## **TECHNICAL BULLETIN**

**505-20-26**

**SUBJECT:** GROUNDING BRACKET IMPROVED  
INSTALLATION, INTRODUCTION OF

**HELICOPTERS AFFECTED:** Serial numbers 65010 through 65157, 65160 through 65244, 65246 and 65247.

**Figure 1 – Welded Truss Assembly (Sheet 1 of 3)**

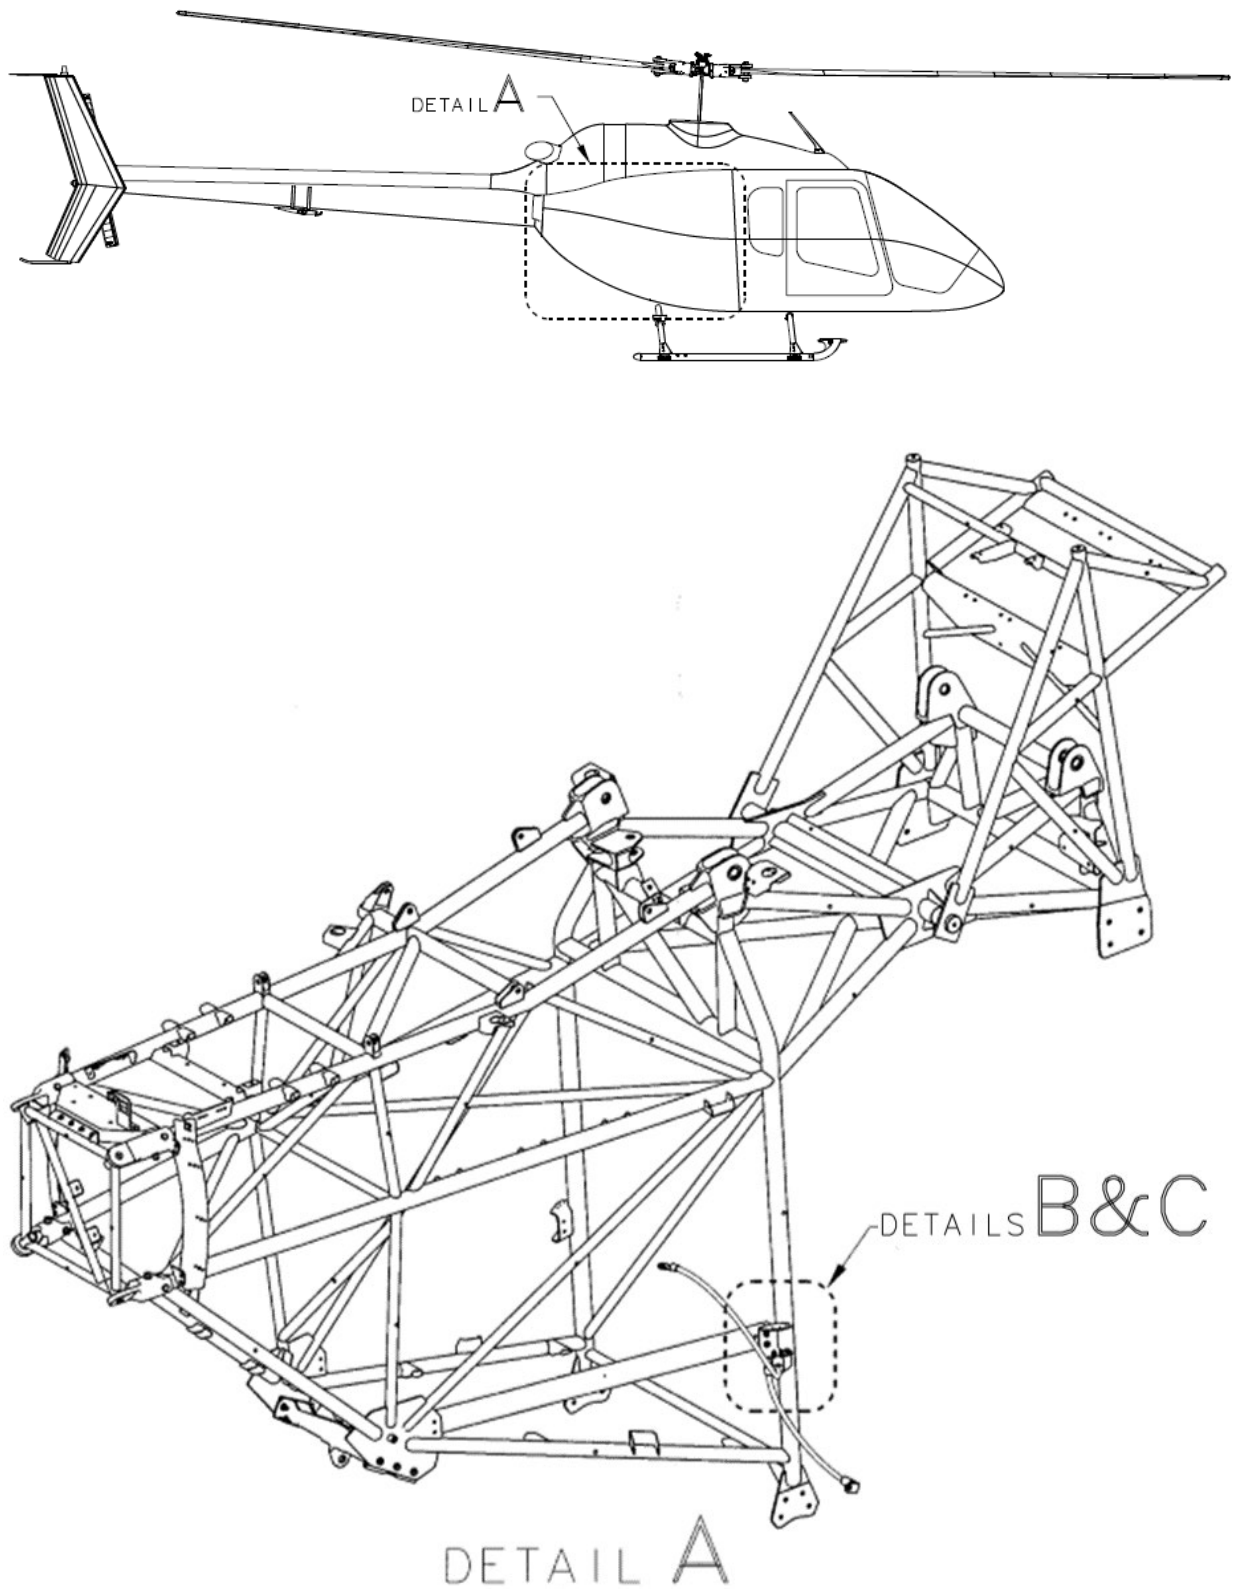
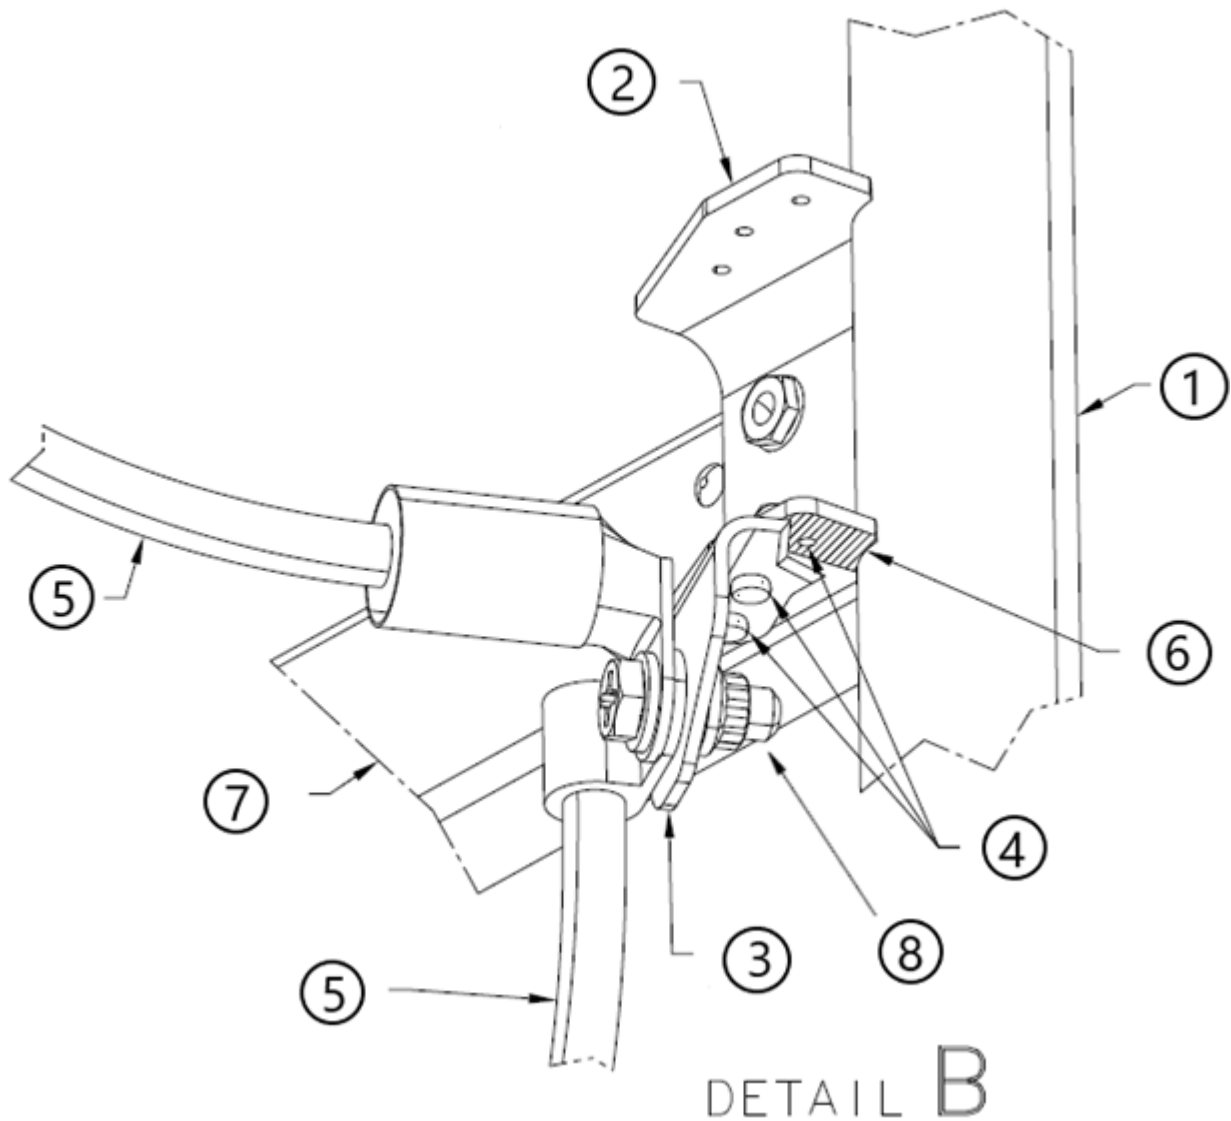
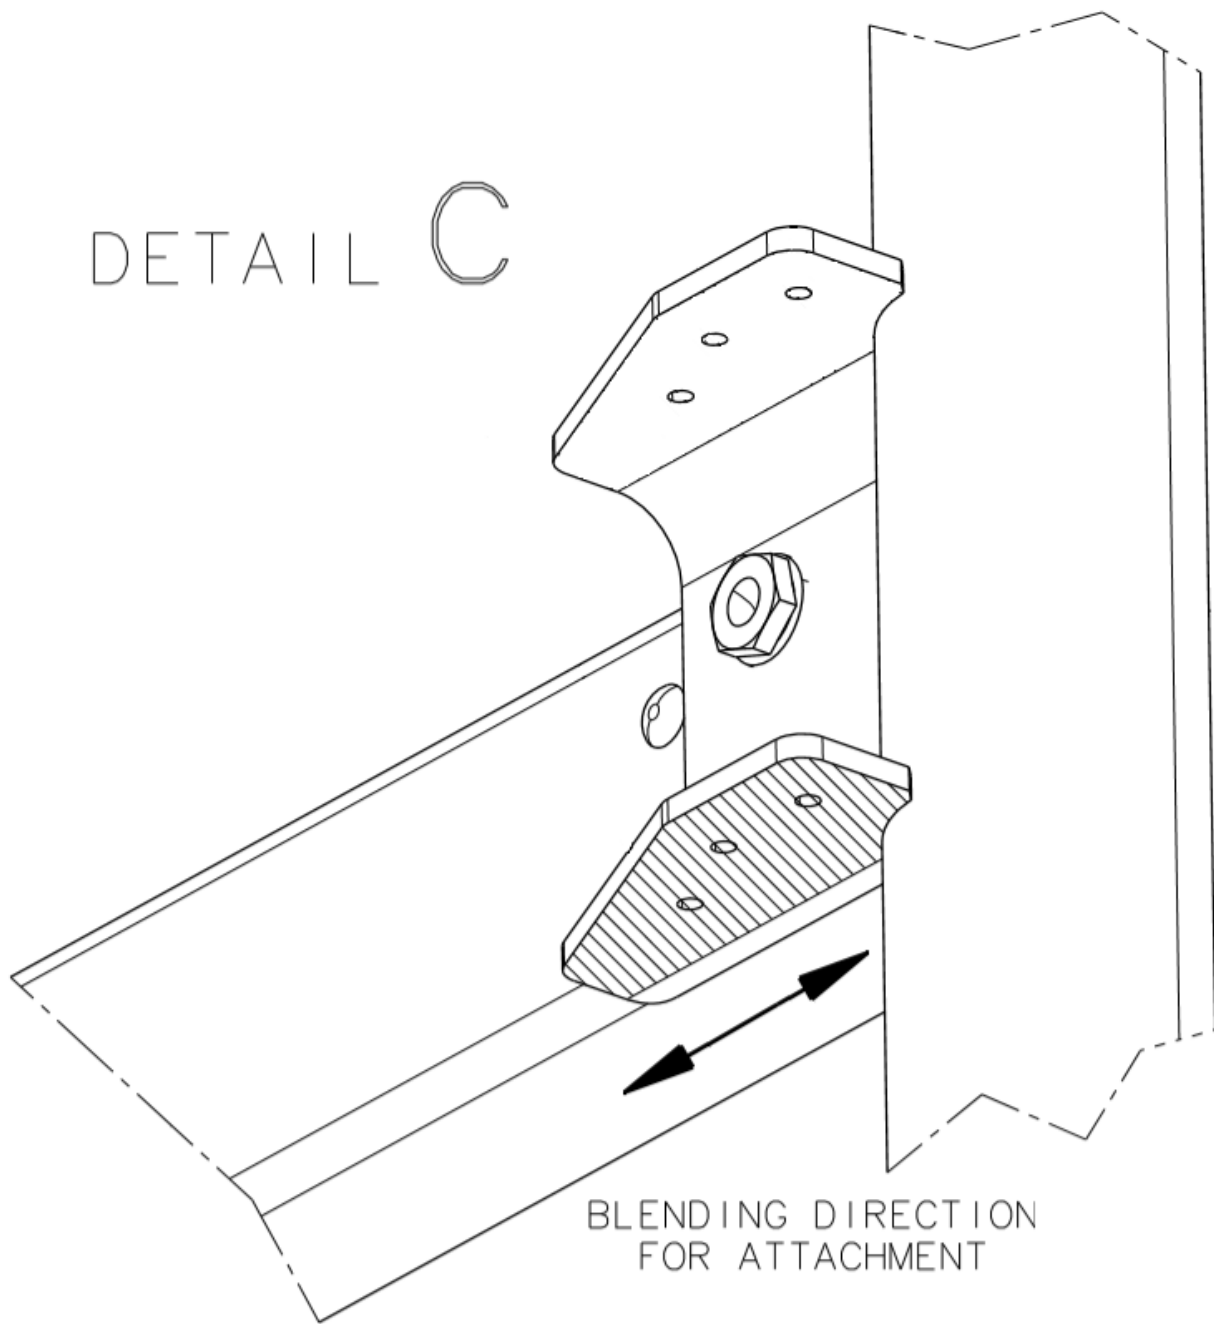
Bell has received reports of degraded connections at the battery ground bracket. To improve the ground connection, Hi-Lok fasteners are now used, for better clamp-up, instead of solid rivets to attach the battery grounding bracket to the welded truss at the RHS avionics tray attachment.

2. Remove rivets (4) (BHT-ALL-SRM) and remove grounding bracket (3) from RHS avionics tray attachment (2).

- 1 - RHS Pylon to Keel Tube (REF)
- 2 - RHS Avionics Tray Attachment
- 3 - Grounding Bracket
- 4 - Rivets, remove MS20470AD4, install 100-159-5 pin & 30-296-5W collar
- 5 - Ground Cables (REF)
- 6 - RHS Avionics Tray Attachment contact surface (hatched)
- 7 - RHS Avionics Tray Support (REF)
- 8 - Attaching hardware (REF)
  - NAS1801-5-13, Screw
  - NAS1149D0563J, Washer (Qty 2)
  - NAS9926-5L, Nut

5. Prepare surface of grounding bracket (3) (BHT-ELEC-SPM, Chapter 8).
6. Prepare cadmium plated surface of RHS avionics tray attachment mating surface (6) (BHT-ELEC-SPM, Chapter 8).
7. Locate grounding bracket (3) on RHS avionics tray attachment (6).
  - a. Make sure the grounding bracket (3) sits flat on RHS avionics tray attachment mating surface (6). See **Figure 2** for example of possible interference.
  - b. If RHS avionics tray attachment weld interferes, blend corner of grounding bracket (3). Do not sand the tray support weld.
  - c. Enlarge holes for Hi-Loks (4) (BHT-ALL-SRM, Chapter 3).

8. Remove grounding bracket (3); deburr all holes; remove debris and loose material.
9. Install grounding bracket (3) with pins/collars (4) wet with sealant (BHT-ALL-SRM, Chapter 3 and BHT-ELEC-SPM, Chapter 8).
  - a. Remove excess sealant squeeze-out.
10. Overcoat fastener heads and tails/collars (4) with sealant (C-251).

11. Install cable assemblies (5) to grounding bracket (3) using previously removed hardware (8), torque 120 to 160 in-lbs plus tare torque.
12. Perform electrical bonding of grounding bracket (3) to RHS avionics tray attachment (2) (BHT-ELEC-SPM, Section 8 for Class C at 0.37 milliohms). Electrical resistance test to be performed from grounding bolt (8) of cable assemblies (5) to RHS avionics tray attachment (2).
13. Prime all bare metal or cadmium plated surfaces (BHT-ALL-SPM, Chapter 4).
14. Apply topcoat to all primed and sealed areas (BHT-ALL-SPM, Chapter 4).
15. Re-finish as required (BHT-ALL-SPM, Chapter 4).
16. Reconnect battery ([DMC-505-A-24-30-04-00A-730A-A](#)).
17. Install right hand aft fuselage panel ([DMC-505-A-53-30-02-00A-720A-A](#)).
18. Make an entry in the helicopter logbook and historical service records indicating compliance with this Technical Bulletin.
